STAFF RECOMMENDATION
1239 6th Avenue North
June 20, 2018

Application: Demolition—addition; New construction—addition
District: Germantown Historic Preservation Zoning Overlay
Council District: 19
Map and Parcel Number: 08209045700
Applicant: L. Lesley Beeman, Jr., AIA, Manuel Zeitlin Architects
Project Lead: Melissa Baldock, melissa.baldock@nashville.gov

Description of Project: Application is to demolish the existing addition and construct a new addition. **Recommendation Summary:** Staff recommends approval of the project with the following conditions: 1. The window openings on the Monroe Street elevation have glazing in them, even if they are painted black or obscured on the interior; 2. Staff approve a brick sample; 3. Staff approve all window and door selections; 4. Staff approve the color and texture of the membrane roof; 5. Staff approve the canopy material; and 6. Staff approve the location of the HVAC units and all other utilities. With these conditions, staff finds that the proposed demolition and addition meets Sections III.E., V., and VII. of the design guidelines.	**Attachments** **A:** Site Plan **B:** Elevations

Figure 2 shows the rear addition that will be demolished.

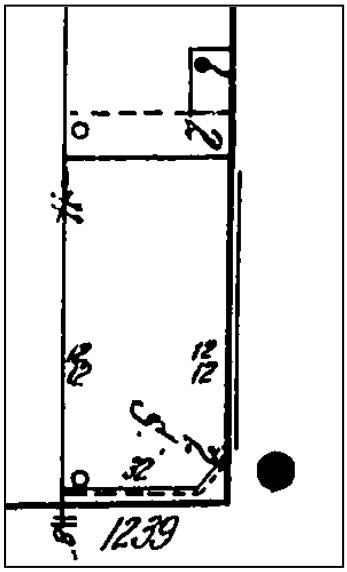
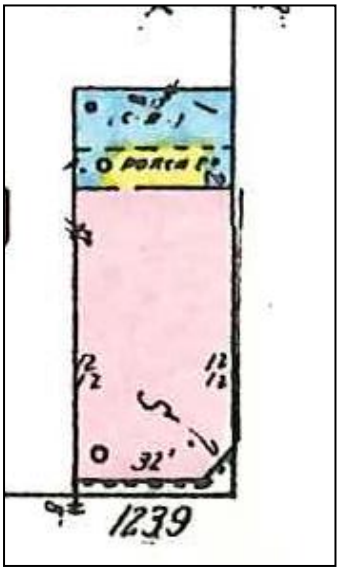
Demolition. The applicant is proposing to demolish the existing rear extension (Figure 2). The date of construction of the rear addition is not known, but the 1914 and 1957 Sanborn maps show that there were rear extensions to the structure historically, but their size and depth are different now than they were then (Figures 3 & 4). Staff finds that the rear extension's materials, form, roof slope, fenestration pattern, and date of construction do not contribute to the historic character of the historic commercial structure. Staff therefore finds that its removal meets Section VII.B.2. of the design guidelines.

Figure 5. Rear of the building as seen from Monroe Street.

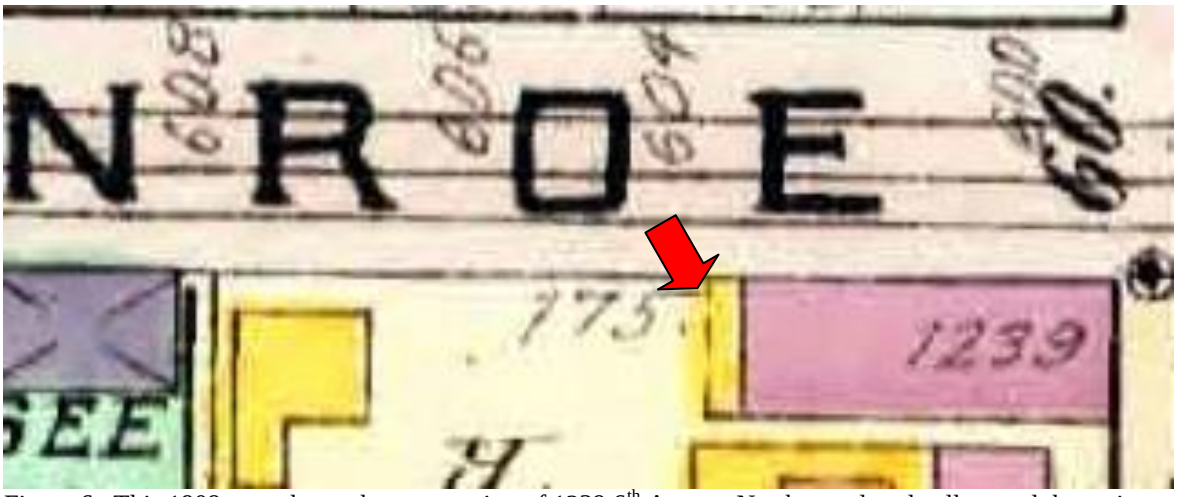
Façade Articulation, Rhythm of Solids to Voids & Proportion of Openings. On the Monroe Street façade, which is the most visible, the second story will largely be casement windows and a storefront frame. Staff finds this to be appropriate, as historically, the rear addition was a two-story enclosed porch (See Figure 3, the 1914 Sanborn Map), which could have been largely open in nature.

1 MONROE ST ELEVATION
1/8" = 1'-0"

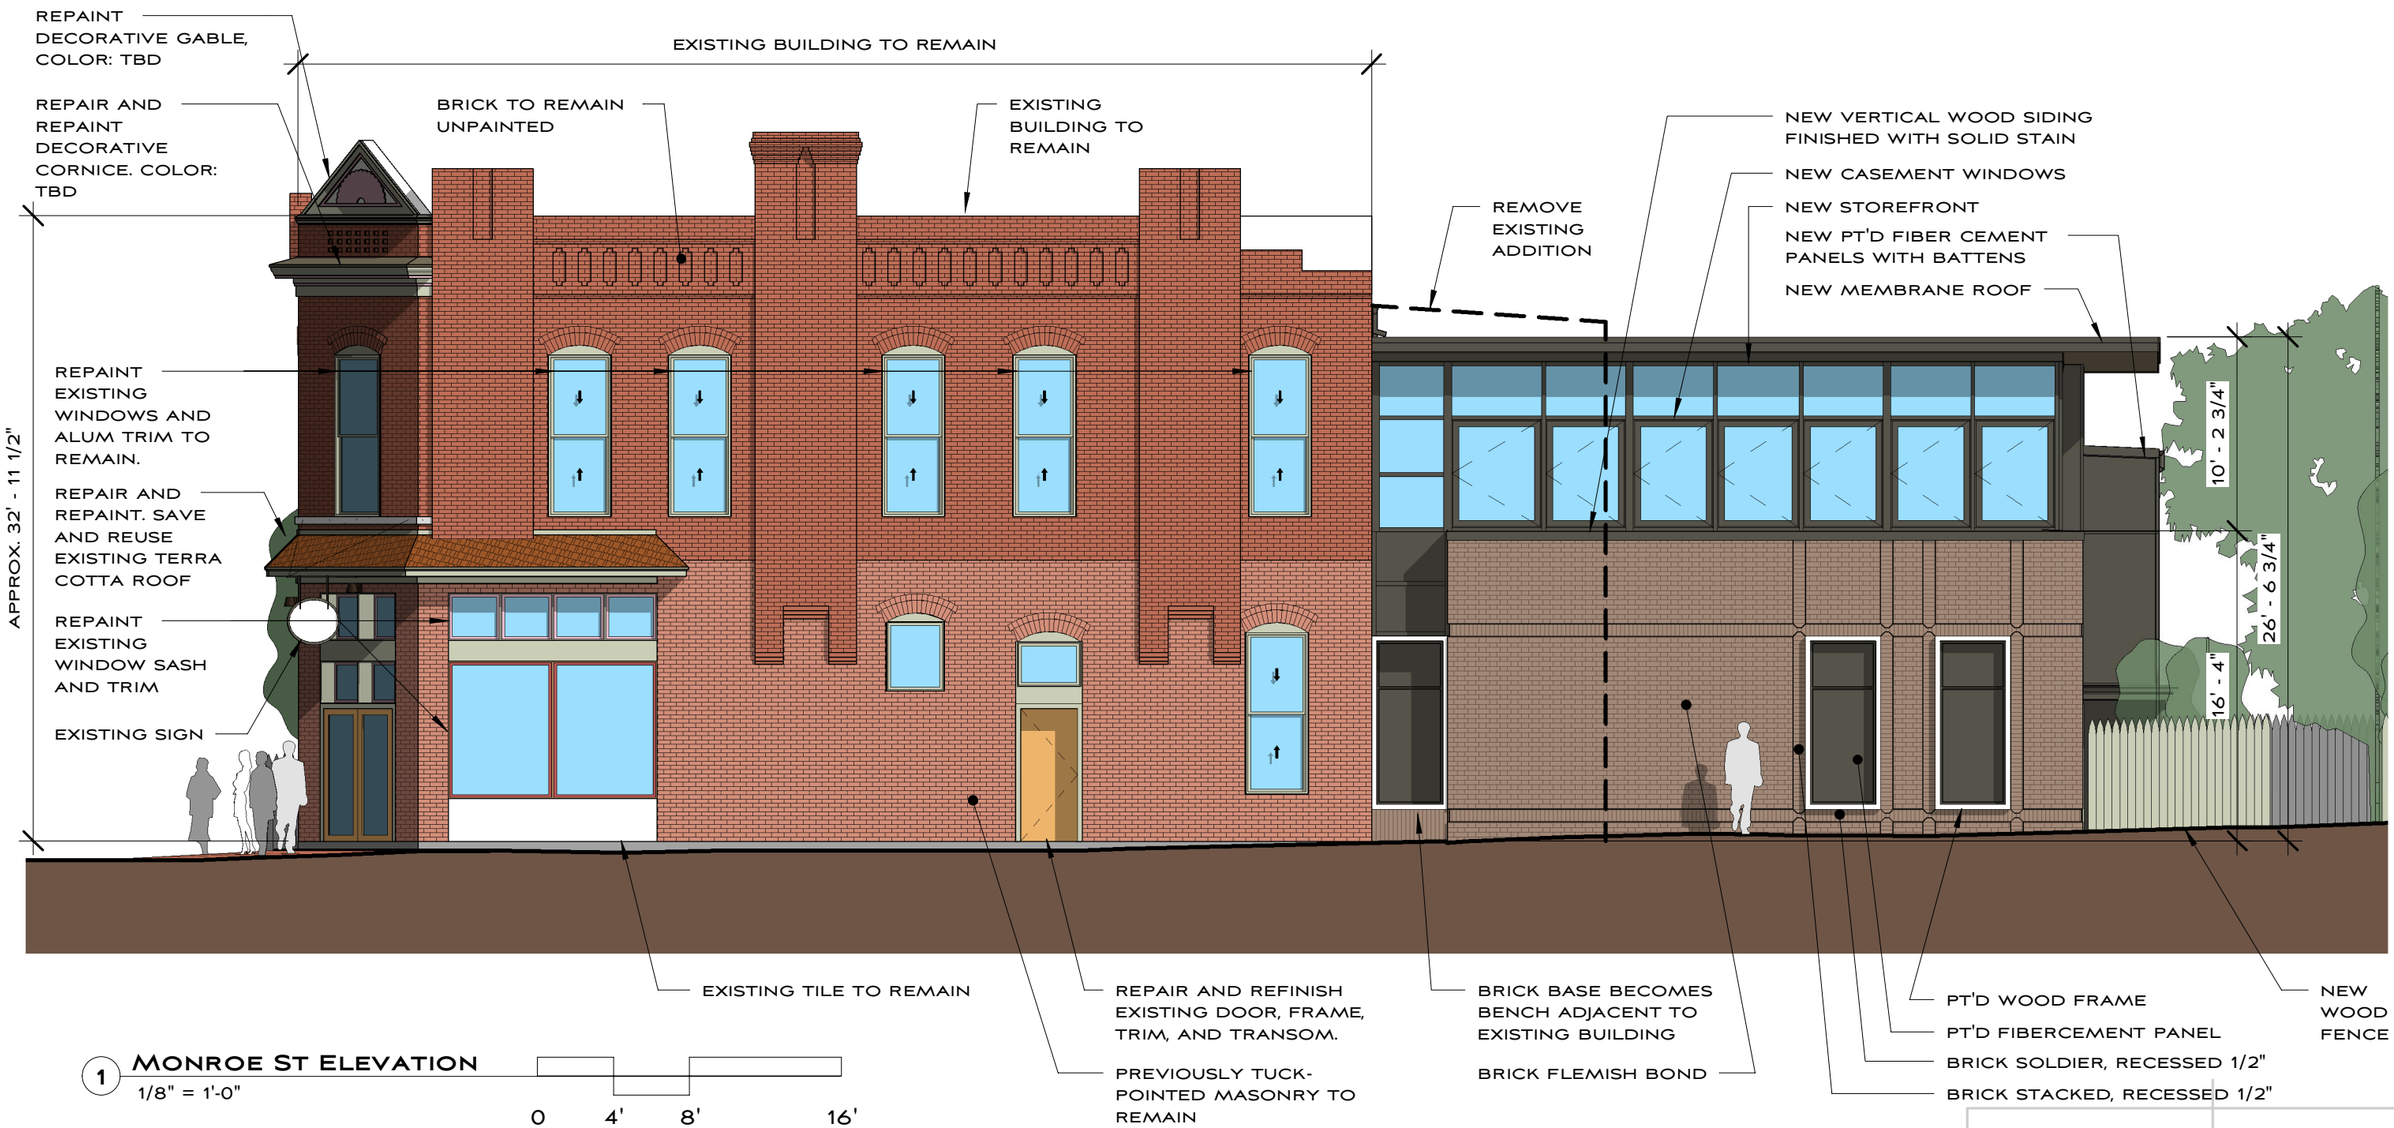
The ground floor of the proposed addition does not have any true glazed window openings. Rather, it has three rectangular areas, with soldier course bricks recessed one-half inch (1/2") and wood frames. In the place where the glazing would typically be, the applicant is proposing to install fiber cement panels. Staff finds that this faux window opening treatment does not meet the design guidelines, which states "On corner commercial buildings, glazing shall address both streets." These openings are not glazed, creating a long wall without any glazing. Staff recommends windows that are frosted or painted black on the interior which will allow the applicant to wall over the windows on the interior. This is necessary because the area will be a commercial kitchen but will still appear as actual windows from the exterior. With this condition, staff finds that the proposed addition meets Sections III.E.4., III.E.6., and V. of the design guidelines.

1. The window openings on the Monroe Street elevation have glazing in them, even if they are painted black or obscured on the interior;
2. Staff approve a brick sample;
3. Staff approve all window and door selections;
4. Staff approve the color and texture of the membrane roof;
5. Staff approve the canopy material; and
6. Staff approve the location of the HVAC units and all other utilities.
